ERRATA SHEET FOR

TENTATIVE ORDER NO. R9-2006-0104

WASTE DISCHARGE REQUIREMENTS AND CLEAN WATER ACT SECTION 401 WATER QUALITY STANDARDS CERTIFICATION FOR RANCHO MISSION VIEJO, LLC, RANCHO MISSION VIEJO RANCH PLAN PLANNING AREA 1, ORANGE COUNTY

Attachment D Figure 8 Planned Open Space Within the Ranch Plan

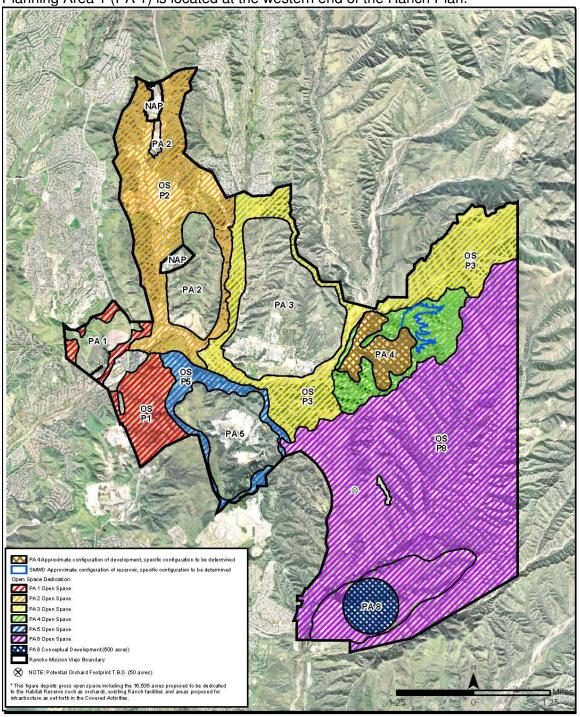
3. Add Figure 8 to the Fact Sheet as follows to show the locations of each Planning Area and corresponding dedicated open space area within the Ranch Plan:

Open space areas (OS) correspond to the eight Planning Areas (PA) within the Ranch Plan. Planning Area 1 (PA 1) is located at the western end of the Ranch Plan.
